DOCKET ITEM #8
Development Special Use Permit #2020-10024
North Potomac Yard Pump Station Building

Application	General Data	
Project Name: North Potomac Yard Pump Station Building	PC Hearing:	December 1, 2020
	CC Hearing:	December 12, 2020
	If approved, DSUP Expiration ¹ :	December 12, 2023
	Site Area:	13,606 SF (0.31 Acres)
Location: 3601 Potomac Avenue	Zone:	CDD #19
	Proposed Use:	Pump Station (Special Use Utility)
	Gross Floor Area:	3,607 SF (Above Grade) 4,718 SF (Below Grade) 8,325 SF Total
Applicant: CPYR Theater, LLC	Small Area Plan:	North Potomac Yard
	Historic District:	Old and Historic Alexandria
	Green Building:	Envision Certification

Public Hearing and consideration of a Development Special Use Permit with site plan for a the above-grade construction of a new pump station building and a waiver to Section 8-200(C)(5)(a) of the Zoning Ordinance for parking accessed from an alley or court.

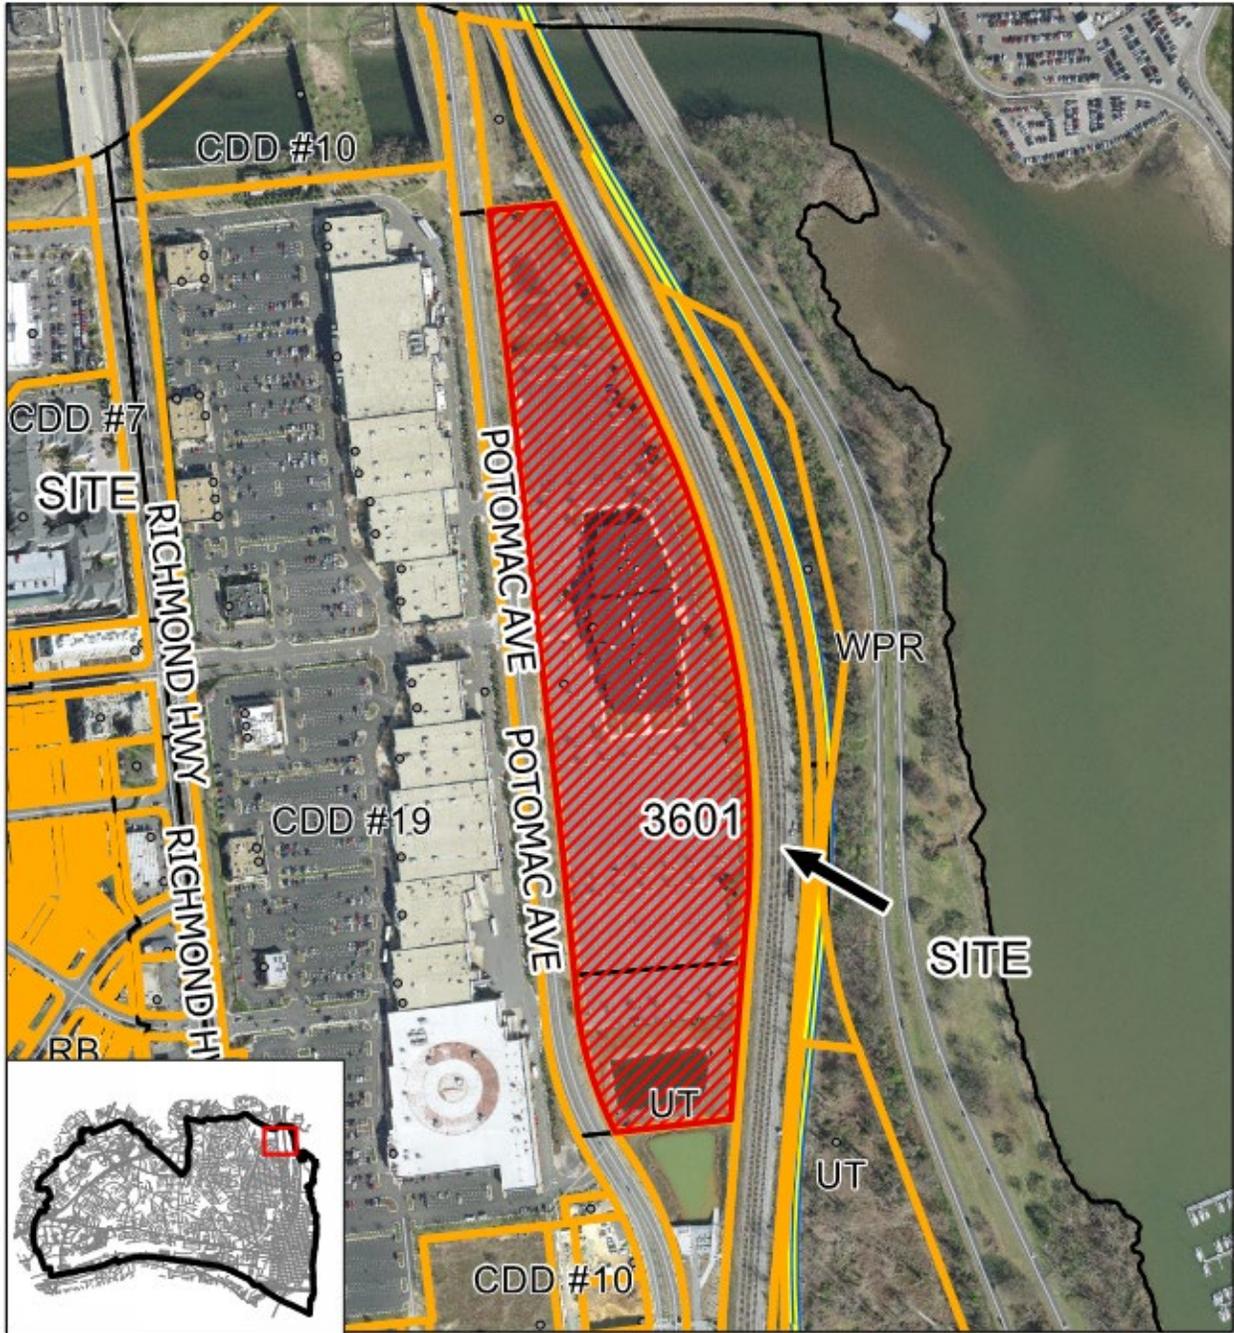
Ms. Sennott did not have much comment on the design and endorsed the project for height,

mass, scale, and general architectural character.

Ms. Roberts indicated that the project should proceed to Certificate of Appropriateness and does not require an additional concept review.

LAYDOWN AREAS

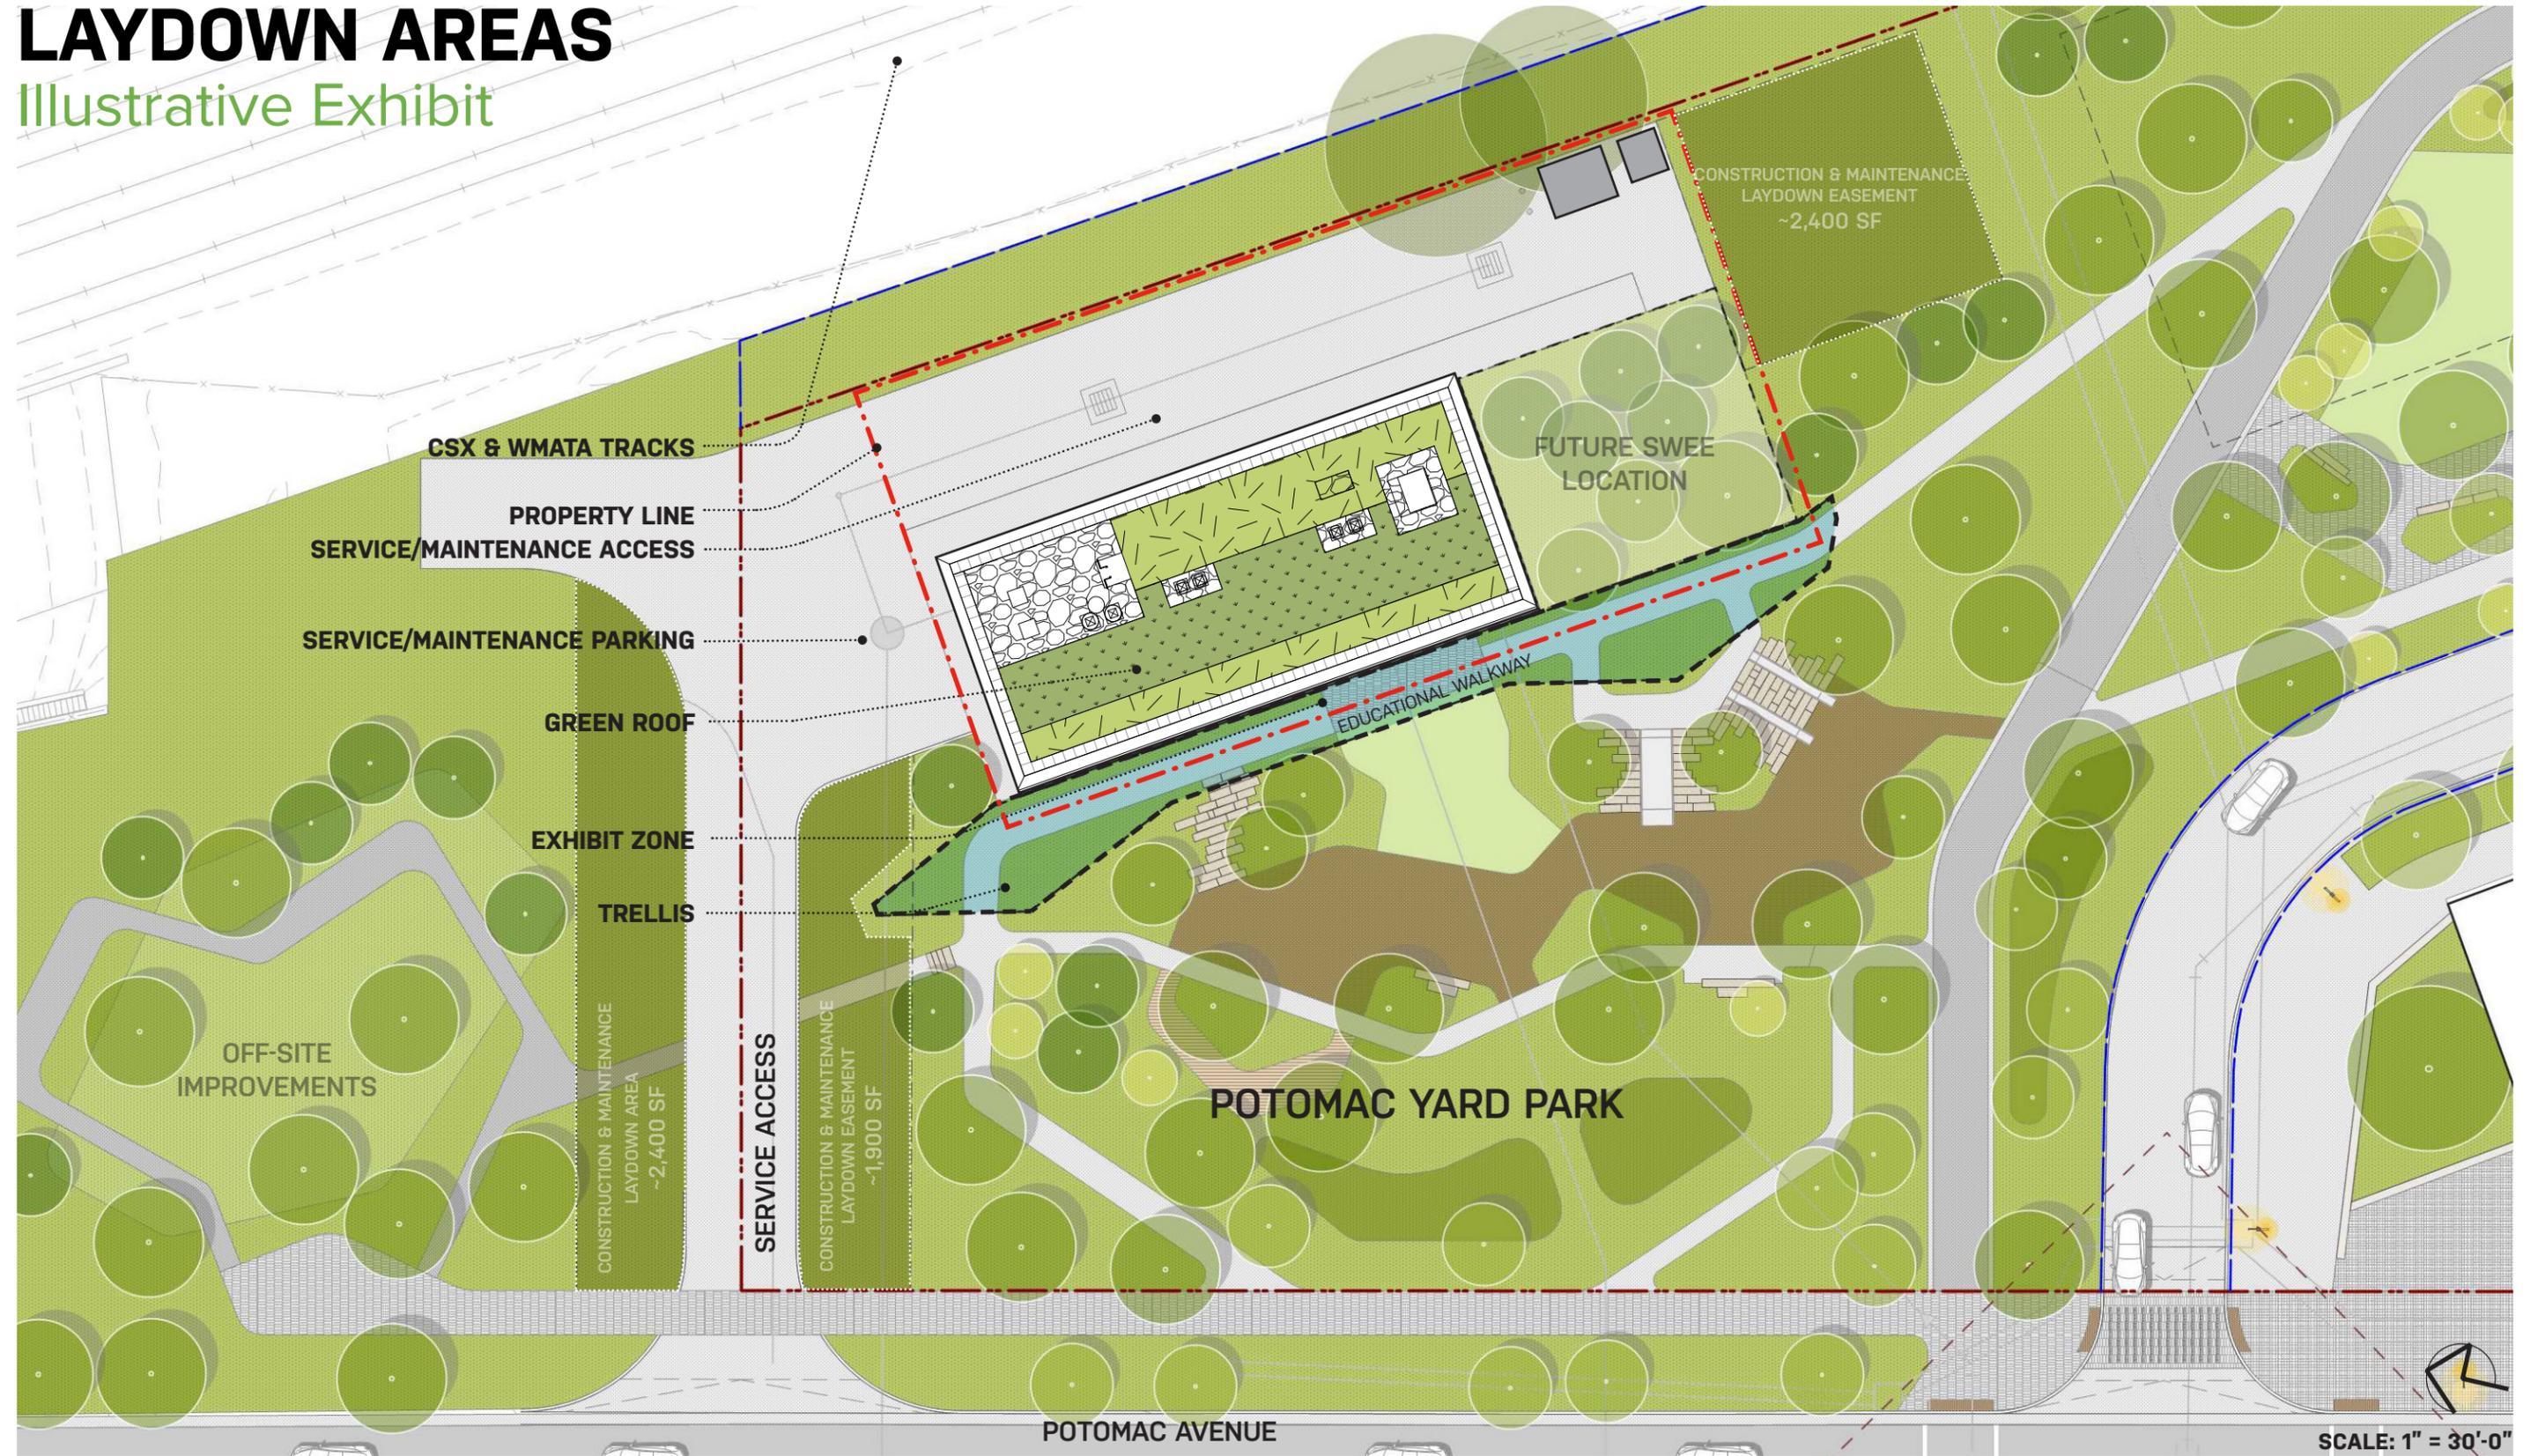
6. Prior to the release of the Final Site Plan, provide the following updates:
 - a. The locations of the construction and laydown areas for the pump station and construction of the future SWEE shall be as shown in Attachment 3.

- b. The location of the above ground transformer and above ground storage tank shall be as shown on Attachment 3.
 - c. Update the final site plan to include:
